FINAL ENVIRONMENTAL ASSESSMENT

***KAPIOLANI REGIONAL PARK  
MASTER PLAN UPDATE***

Waikiki, District of Honolulu, O'ahu, Hawai'i

April 2008

**FIGURE 11**  
**SIDEWALK - WIDENING IMPROVEMENTS**

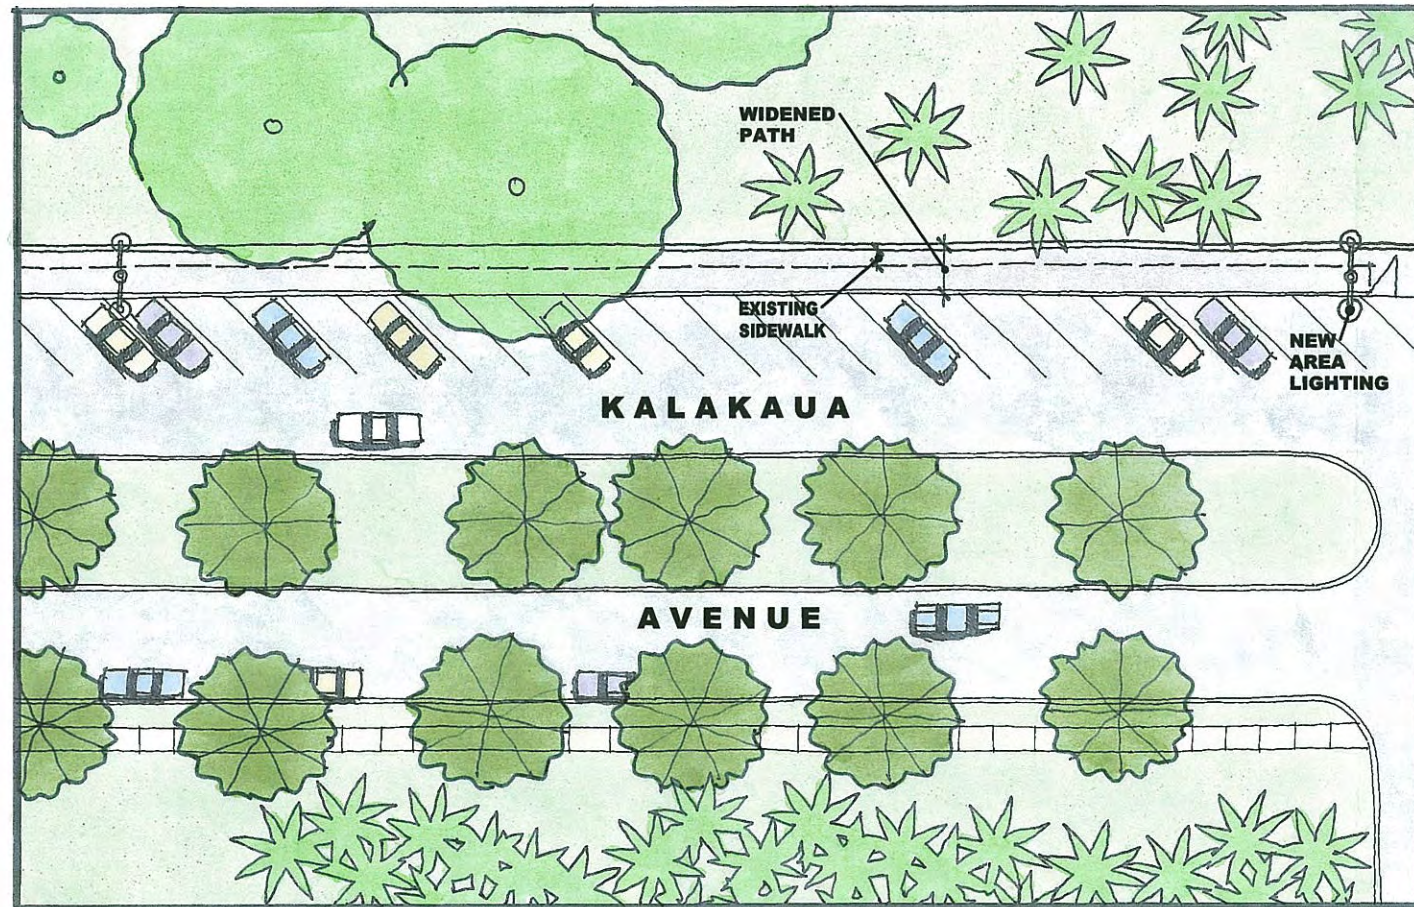
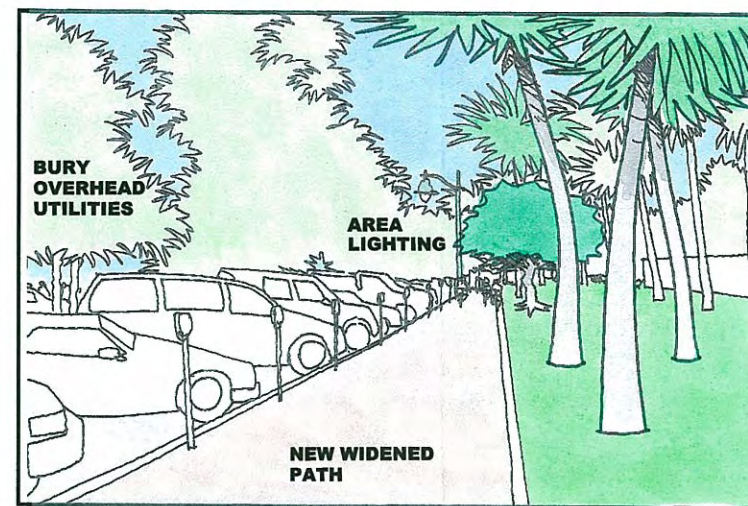
Regarding Figure 11 on page 36, consideration should be given to retaining the planting strip on the mauka side of Kalakaua Avenue and widening the sidewalk along its mauka edge. Street trees within the planting strip can provide additional shade for pedestrians and parked vehicles.

In addition, a wide linear pathway of heat-reflecting paved surfacing is proposed to be constructed to the curb running the length of Kapiolani Park between Monsarrat Avenue and Paki Avenue. This will have a significant negative hardscape impact on the Park's historic landscape between the central green open space and the historic ironwood alley along Kalakaua Avenue. As illustrated by Figure 11,<sup>39</sup> this harsh alignment resembles an aircraft landing strip within the historic open space.

2. The areas to be improved with widened walkways were identified in the DEA. Please refer to Section 1, Item 1, Honolulu Zoo Entrance and Item 2, Walkways Widening on page 2, and Figure 3 Master Plan on page 8.

**FIGURE 12**  
**PAKI AVENUE IMPROVEMENTS**

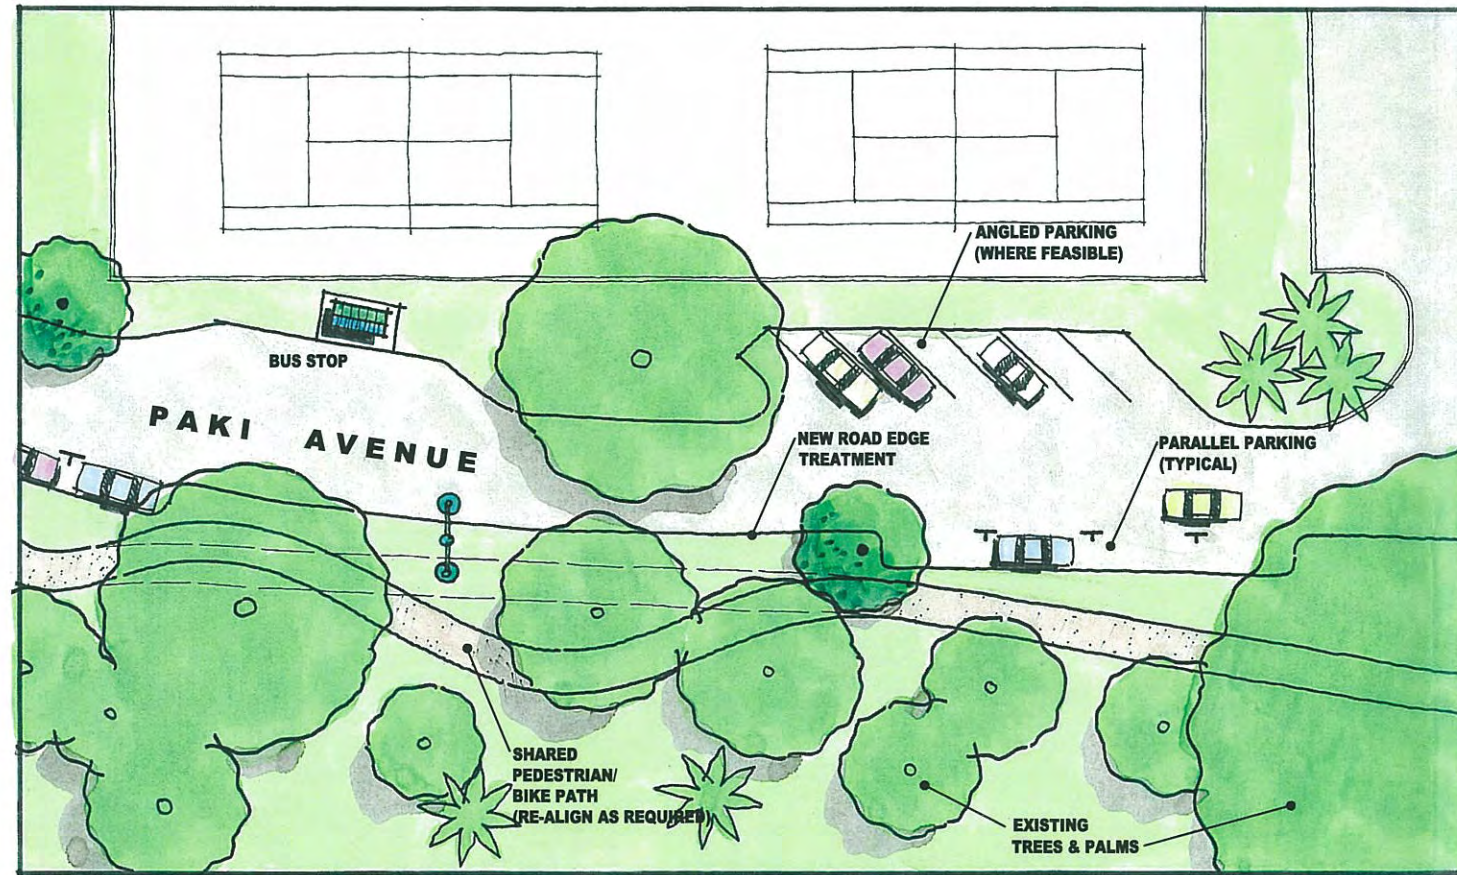
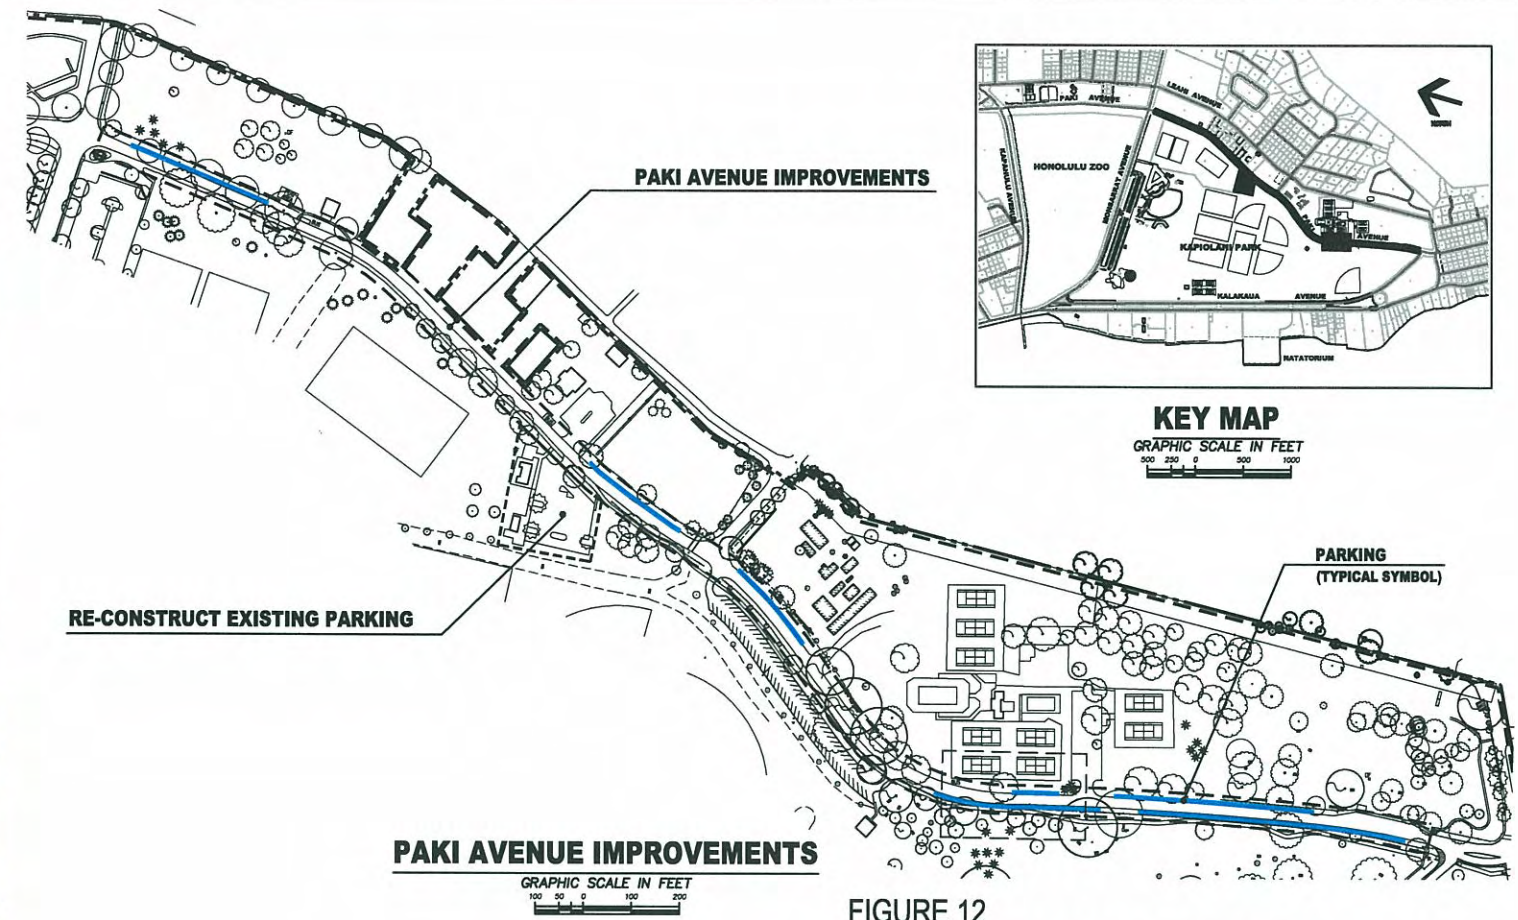
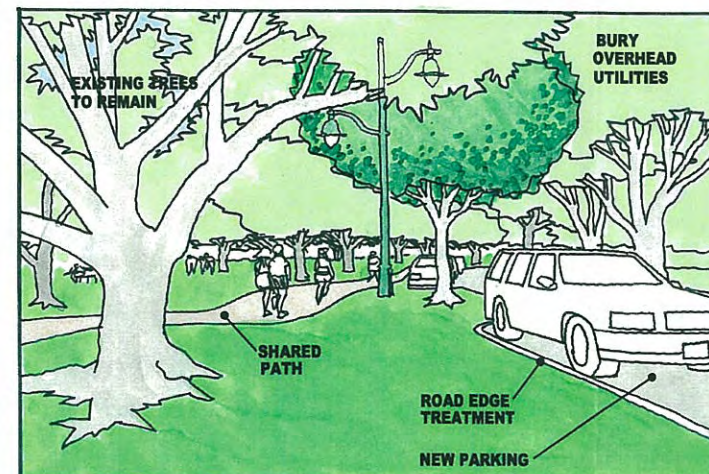
1. Not until page 37 is it mentioned that an "existing comfort station" will be replaced.
2. Where is the comfort station located?
3. Will it be larger or the same size as the existing comfort station?
4. Pg. 38 states that "The proposed improvements will not place additional demands on water and wastewater systems because facilities requiring water and sewer service are not proposed." Yet, Figure 12 states that an existing comfort station will be replaced. Will new stalls be added to the new comfort station? If so, how many and what is the impact on the sewage system?

Page 37, Figure 12, Re-Construct Existing Parking What is the age of the existing structures and comfort station to be demolished?

1. A suggested or possible design treatment was shown as Figure 12 (p. 37) of the DEA. More detailed design and/or construction plans for improvements on Paki Avenue as proposed in the Master Plan Update will be prepared when the City funds actual construction of improvements. It is the intent of the Paki Avenue improvements to upgrade the present conditions to address issues of traffic flow, public safety, and the protection of existing trees. The proposed improvements to Paki Avenue are compatible with the general historical status of Kapiolani Park as the proponents perceive it.

Paki Avenue improvements will be planned and designed to address the issues of traffic flow and public safety according to professionally acceptable standards. Diagonal and parallel parking bays depicted in Figures 3 and 12 are shown as possible configurations where feasible. The Master Plan Update does not propose raised curbing to mark the edge of the roadway. The term curbing was used to allow flexibility in the design of the road improvements.
